Docket Item #1
BAR CASE # 2011-0052

BAR Meeting
May 4, 2011

ISSUE: Alterations (Window Well Installation)

LOCATION: 917 South Saint Asaph Street

Figure 11. Proposed Front Elevation

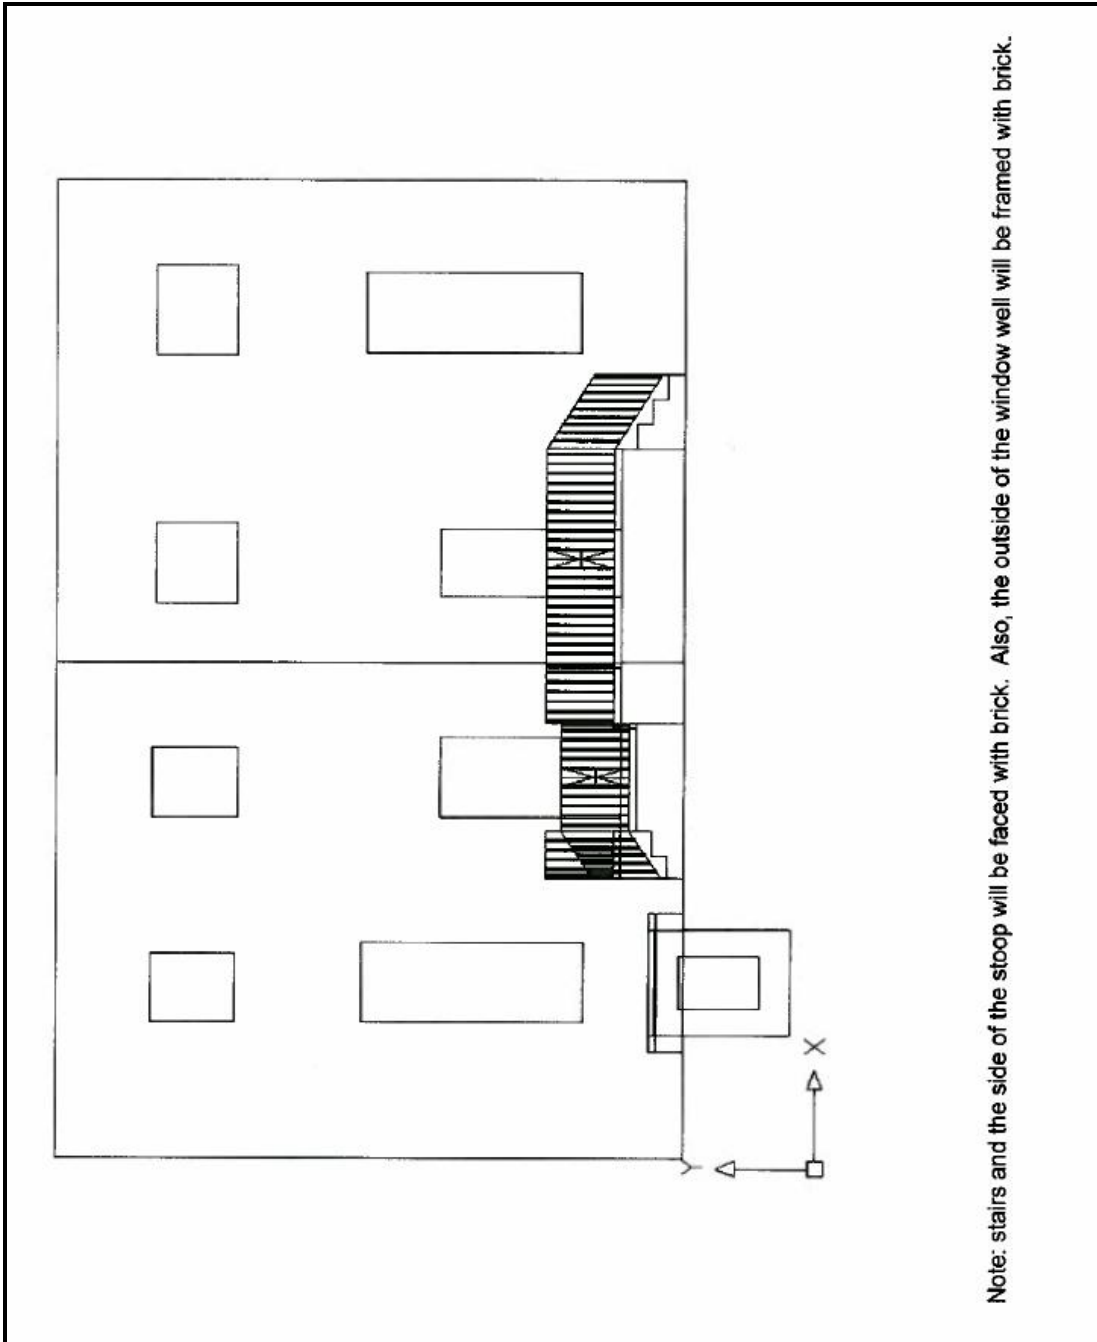
While the Board generally discourages substantial alterations to the principal elevations of buildings within the historic district, the proposed window will only extend approximately 7" above grade and the façade is set back from the sidewalk behind a landscaped front yard. Additionally, the proposed painted, wood, simulated divided light window with the 7/8" muntin is consistent with the Board's Window Policy as an appropriate window option for this c1940s townhouse. Finally, Staff does note that the proposed window well cover is not historically appropriate and manufactured from a modern material (polycarbonate). Generally speaking, window wells within the historic district are covered with metal grates. However, in this situation, due to the desire to divert water away from the new well, staff does not object to the clear, flat polycarbonate cover, which does no harm to the existing structure and is easily removable in the future.

The window to be installed will be located on the basement level, centered below an existing 12/12 double-hung window. The single, double-hung window to be installed measures 30-3/8" in width and 45-1/2" in height, and will be a six-over-six, double-glazed, double-hung, simulated divided light, wood Marvin Wood Ultimate window. The proposed simulated divided light window will have an interior spacer bar and applied interior and exterior muntins. The muntin width will be 7/8 inch. The new window well measuring 62 inches in length, 43 inches in width and approx. 53" in depth supported with a painted, rectangular corrugated, galvanized steel wall support *clad above grade with a brick curb* and capped with a heavy-weight polycarbonate rectangular, flat fabricated window well cover.

Figure 12. Proposed Stoop and Stair Elevation

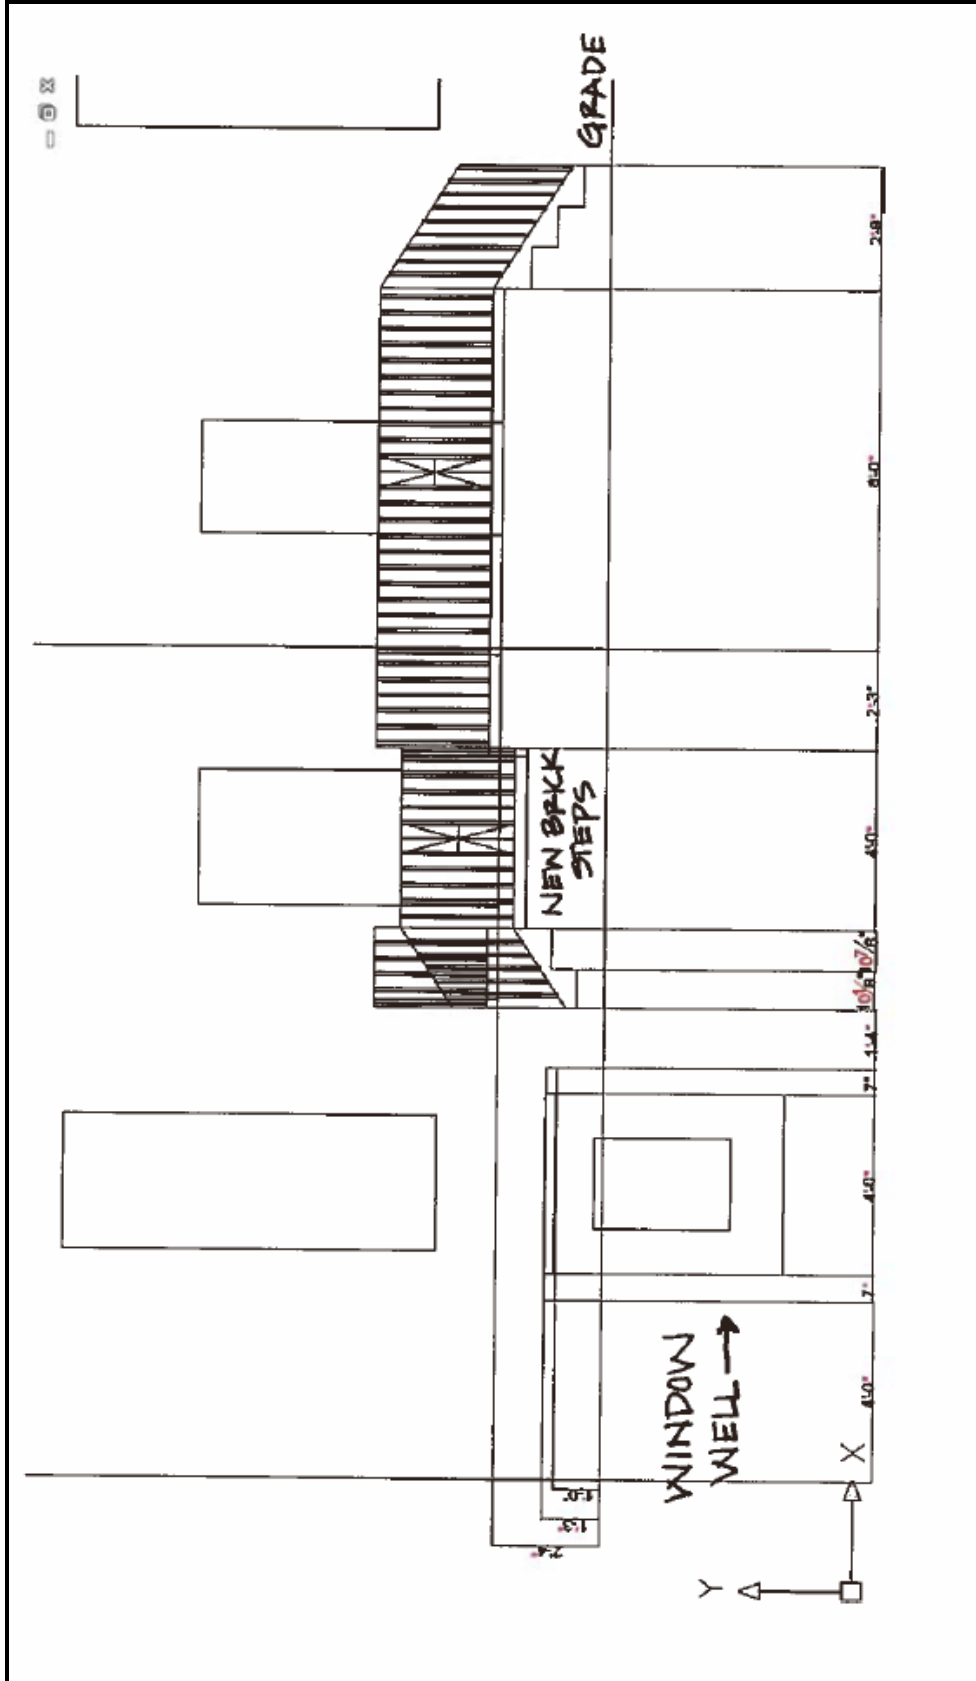
Update: At the April 6, 2011 hearing, the Board deferred this item for further study of the front porch stairs. The Board asked the applicant to restudy the configuration of the stairs and to provide more details in the submitted drawings. The Board did not request a restudy of the egress window being proposed on the basement level of the front elevation.

After the Board's deferral at the April 6, 2011 hearing, Staff met with the applicant again to address the Board's concerns regarding the design and the information contained in the drawing submittal. The applicant has revised the configuration of the front porch staircase, making it more rectangular, as suggested by the Board, in lieu of the previous winder steps. The applicant has also provided the additional drawings the Board requested, showing the reconfigured steps and handrail. Staff believes that the current application addresses the Board's outstanding issues and recommends approval of the application, as submitted.

The applicant also proposes to demolish and relocate the side-loading, brick stairs which lead up to the front entry stoop. *The new brick stairs will extend from the front of the existing stoop and lead down to the existing brick patio. The existing wrought iron railing will be removed and reconfigured to accommodate the new stair location. The reconfigured railing and new steps will match the existing design details.*
